HAVELOCK FARM

DESIGN, ACCESS AND
SUSTAINABILITY
STATEMENT

Project ref: 2280-2

Planning Scheme- Ground Floor Plan NTS

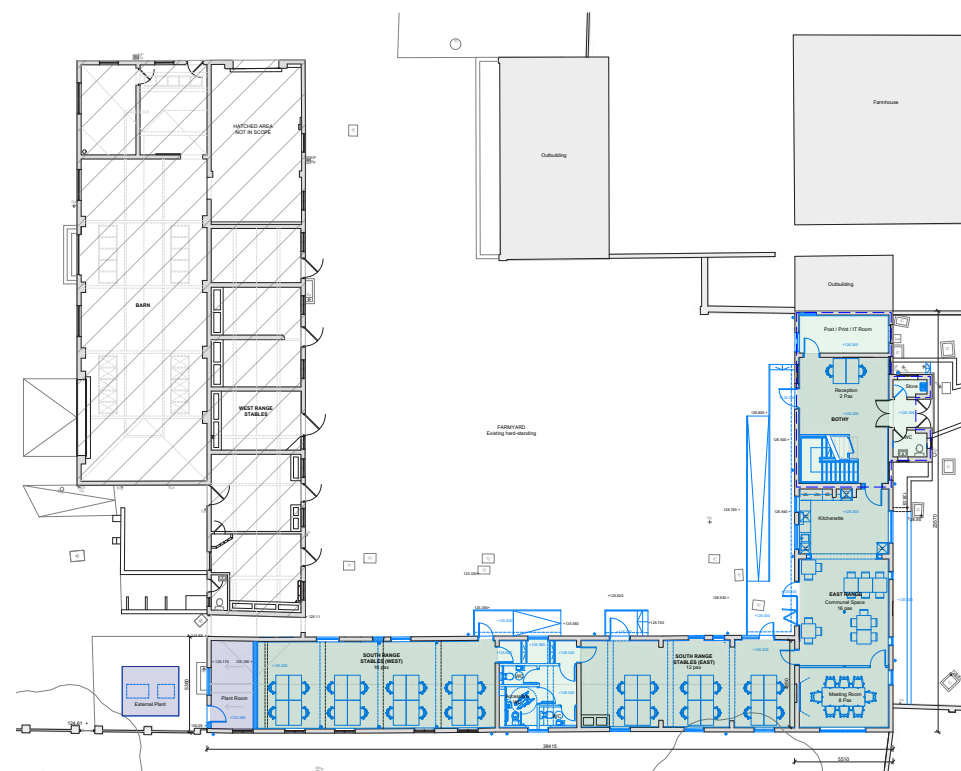
- The pre-app proposals were considered by the Planning Officer as being acceptable in principle.
- The Conservation Officer welcomed the beneficial long-term use of the buildings, recognised that the original agricultural use on the site is no longer viable and outlined that there would be no objection to the proposed uses on the site.
- The Conservation Officer outlined that elements of the proposed works required reconsideration to ensure that the significance of the Havelock farmstead as an NDHA and the positive contribution which it makes to the settings of the adjacent designated assets are preserved.

- The educational use is no longer proposed, with office use only.
- The Barn and West Range are no longer part of the development site.
- Proposed internal partitions, new openings, and blocked-up openings in south-west range have generally been omitted allowing the existing space to be appreciated.

Key Plan of Views Towards South Range Roof

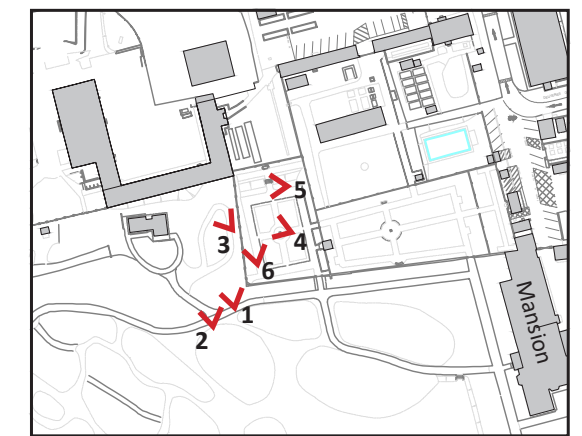
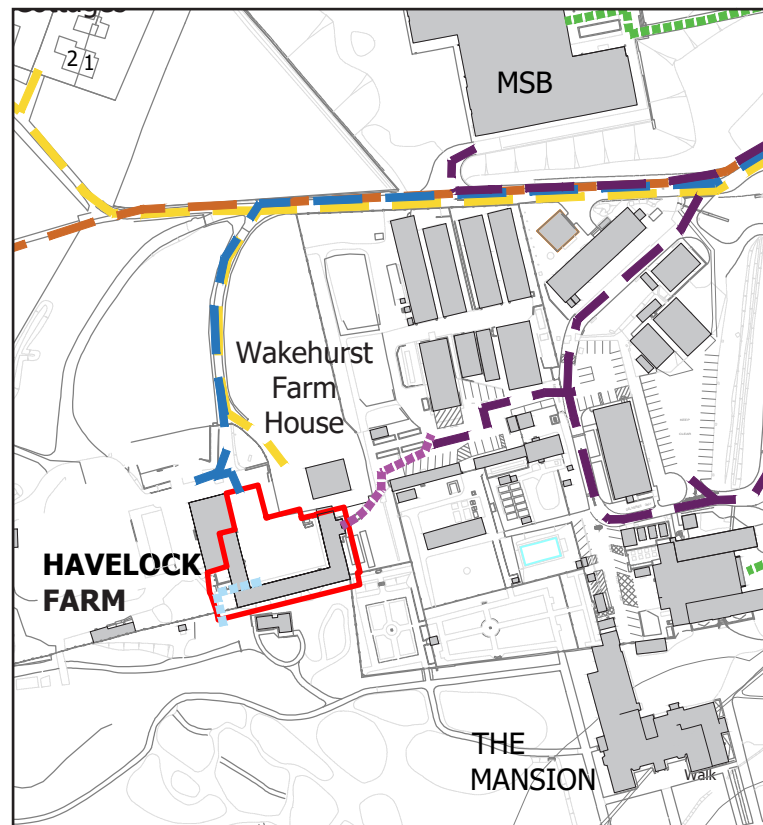
- *The proposed roof plan shows possible locations for new solar or thermal panels. We have no details of this aspect of the proposal at the moment, but the locations for these installations should be carefully chosen to minimise their visual impact, including on glimpsed views of the farmstead from within the adjacent RPG.*

- Photovoltaic panels are located on the south facing roof of the south range (the pre-app scheme extended these on the west range roof now omitted). Existing PVs to be replaced. Extent of the proposed PVs will be partially concealed from within the RPG by the existing WC block and vegetation at the boundary of the gardens. The sustainability benefit of incorporating the PVs is balanced with the small impact on glimpsed views from the gardens- refer to images in this section and Heritage Impact Statement.

It is considered that the slight visibility of the PVs from the gardens from afar is justified when balanced with the sustainability benefits of installing a renewable energy source for the building.
